# Central Square

# Central Square Proposed TDR Districts

## Proposed Edits: Plan & Recommendations

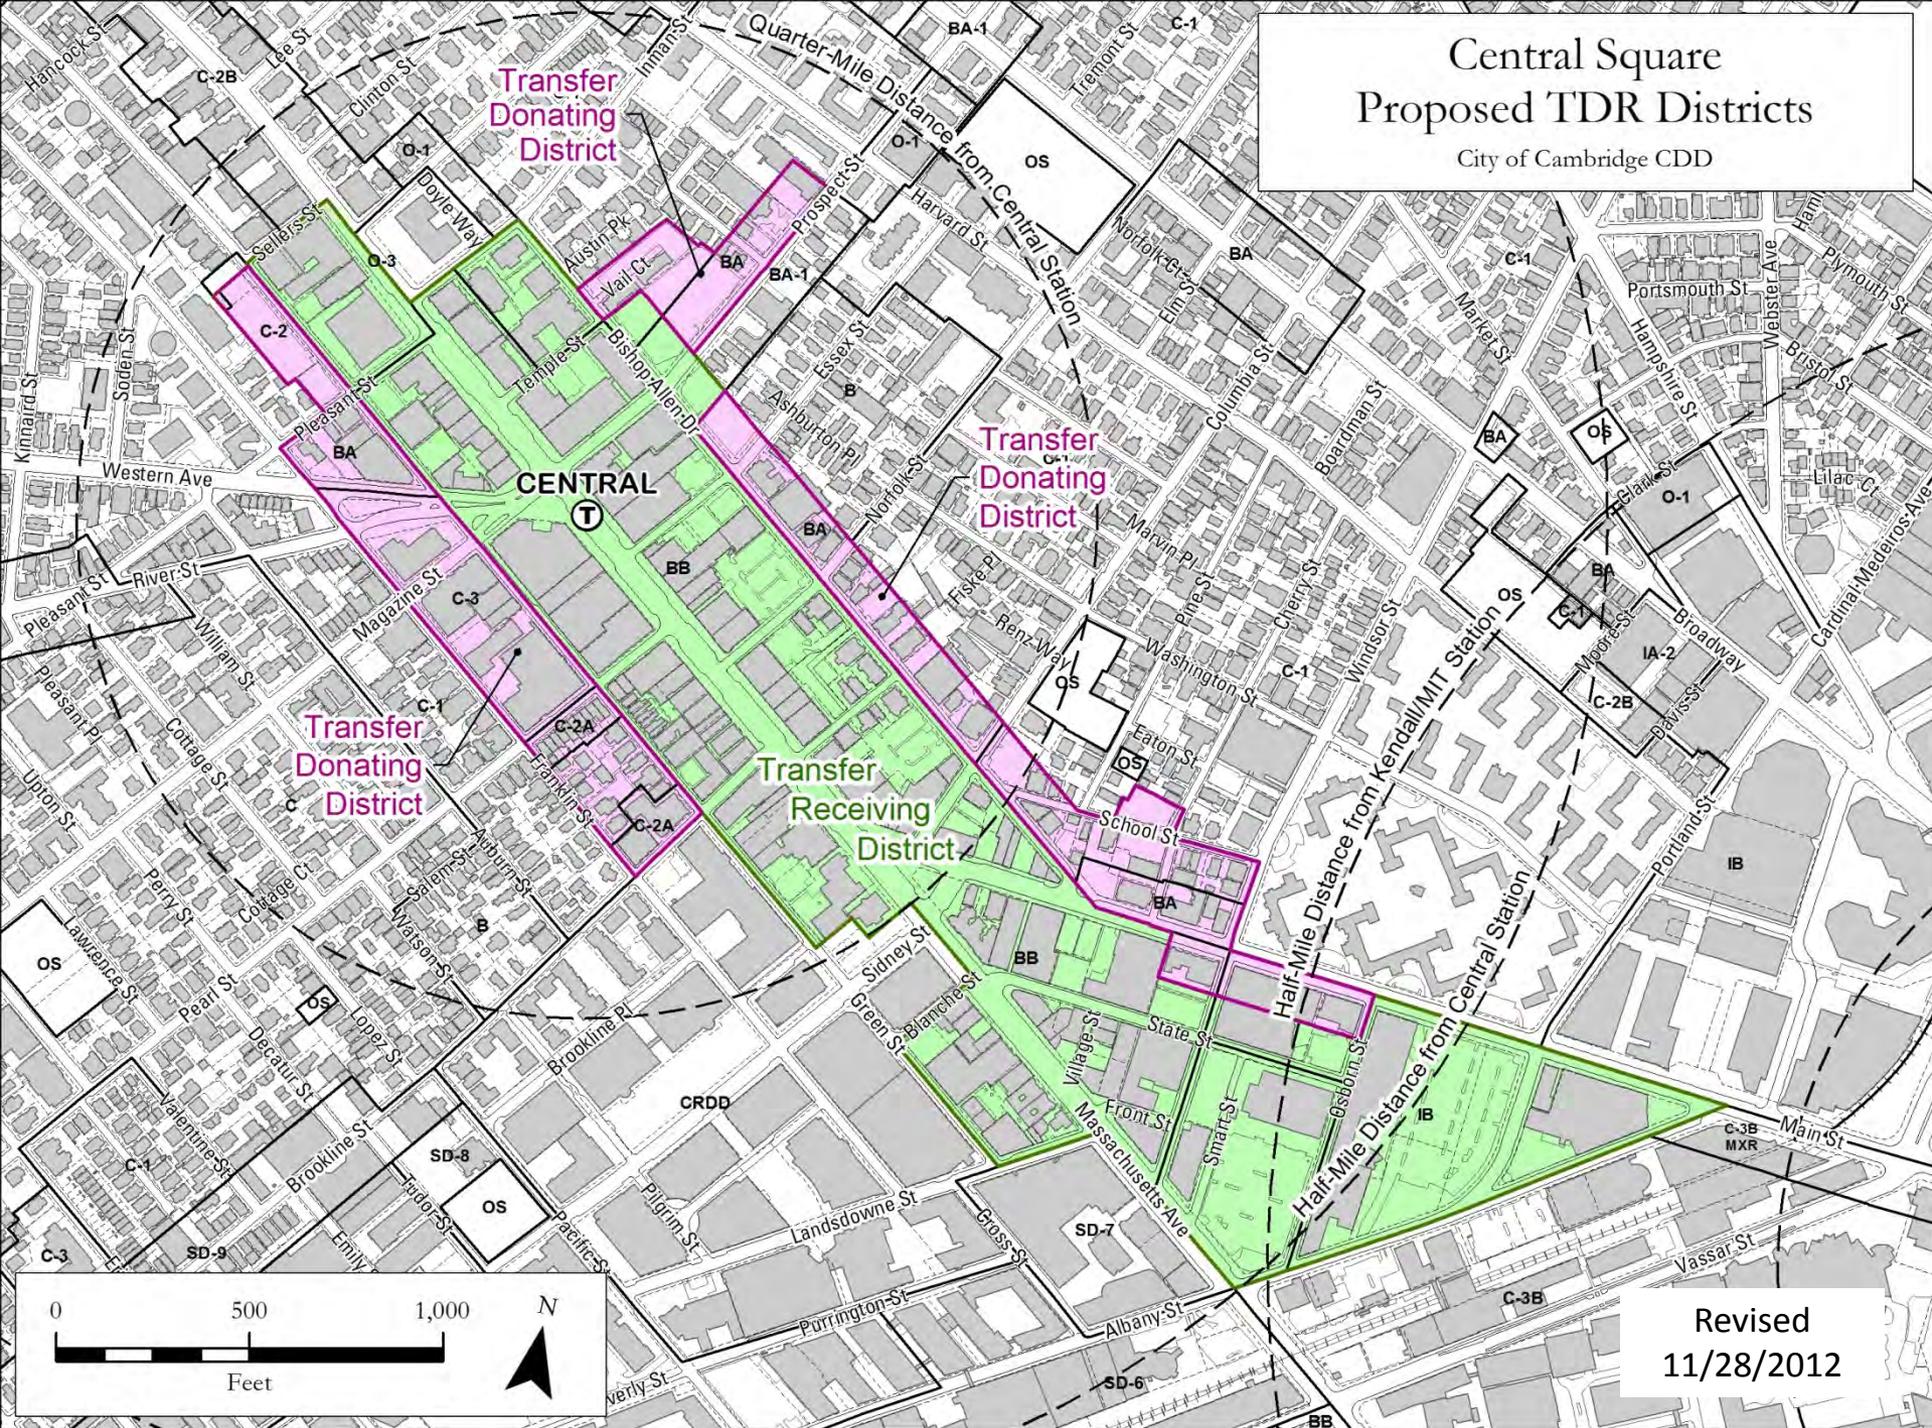
6. Clarification of TDR provision
  - Special permit GFA is used for the calculation of amount of floor area available for transfer
  - Middle income requirement does not apply to transferred GFA

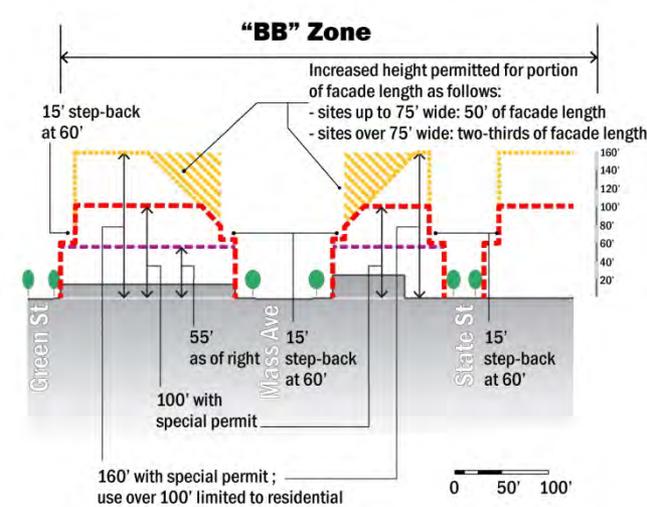
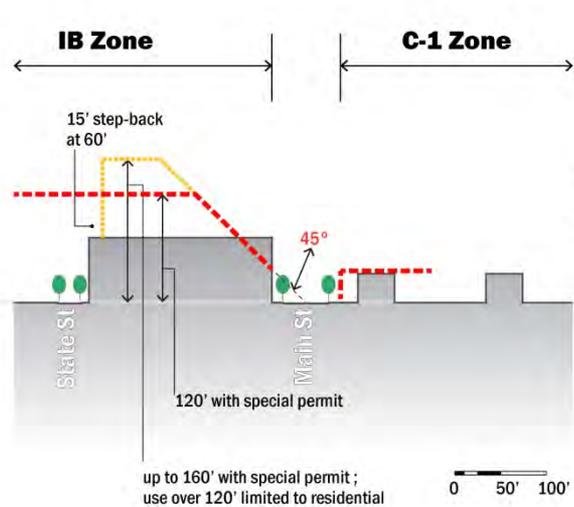
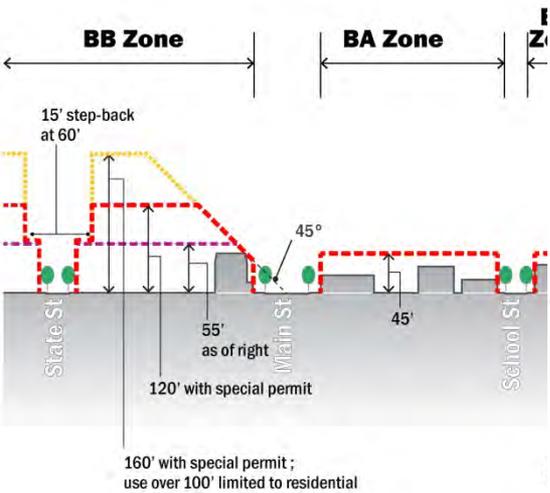
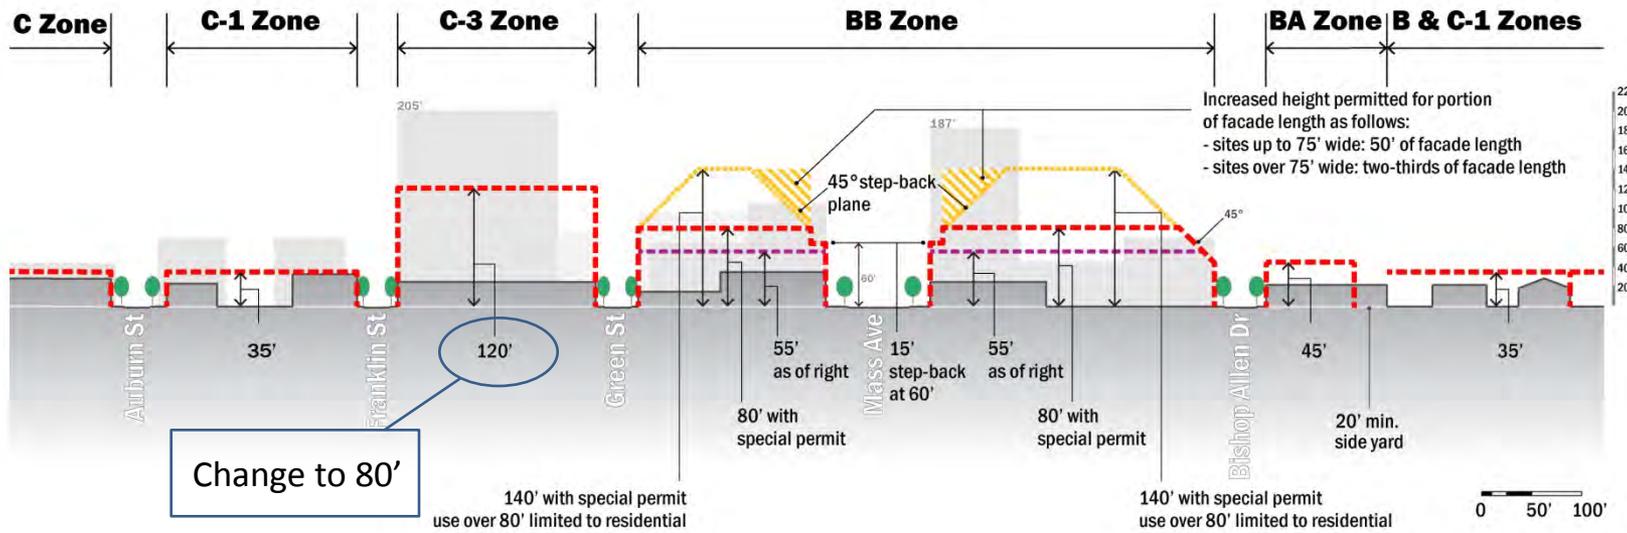
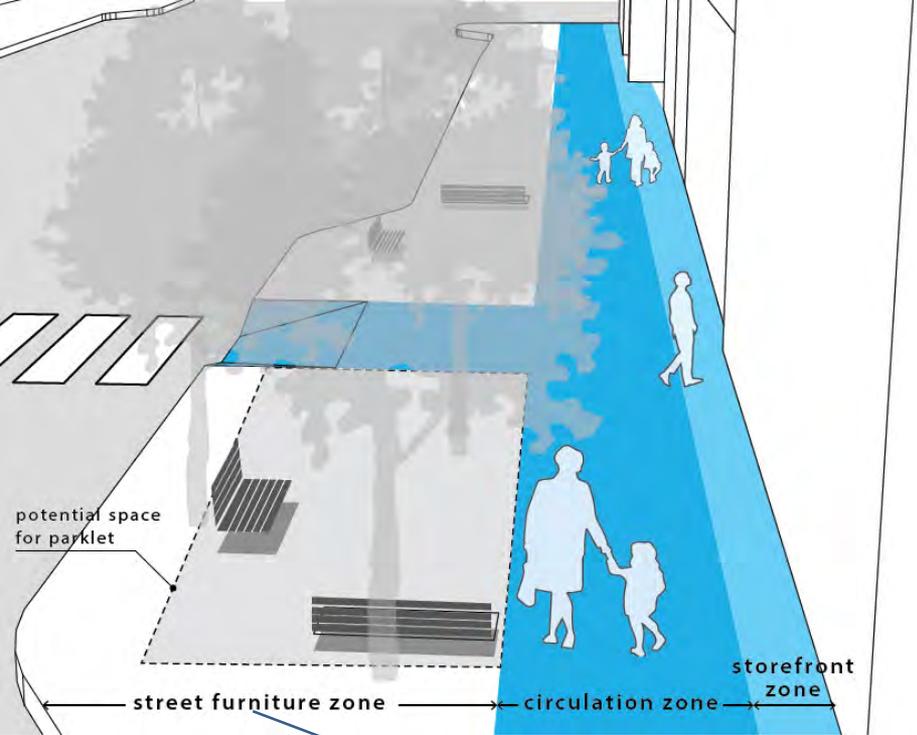
45 ft streetwall  
with some variations

55 ft as-of-right streetwall  
with some variations

55 ft as-of-right streetwall  
with some variations

Change to 'Street Furniture, Art & Activity Zone'

## Public Places Framework

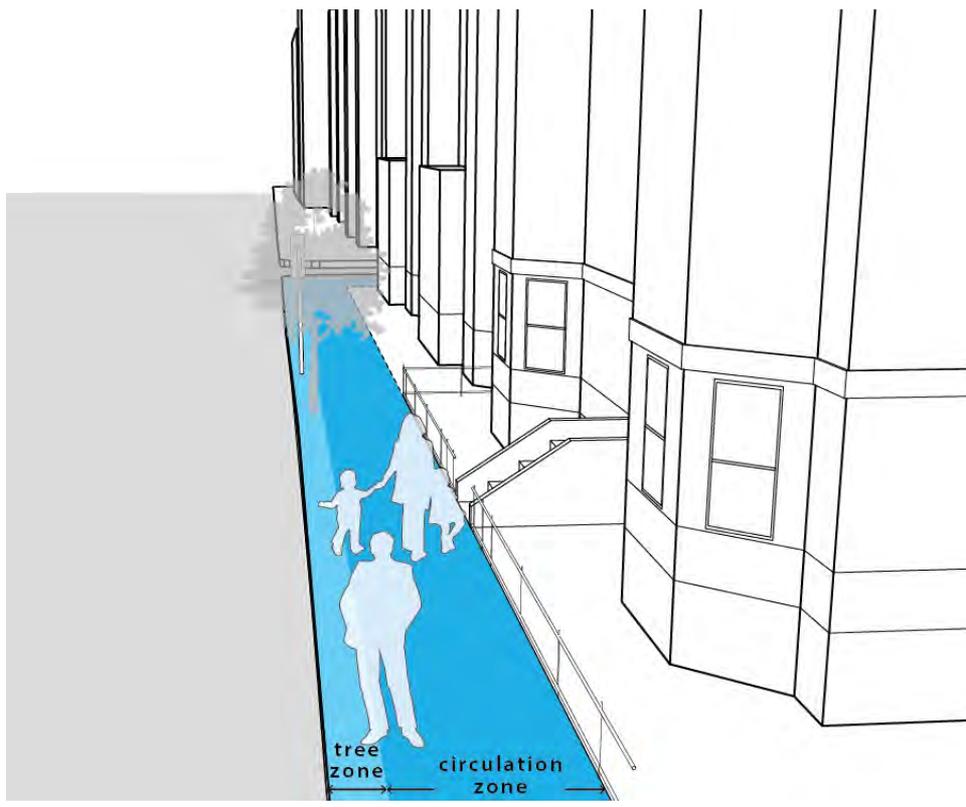
Clarify that loading and parking activities will need to be accommodated on side and back streets, including those noted for 'priority streetscape improvements'
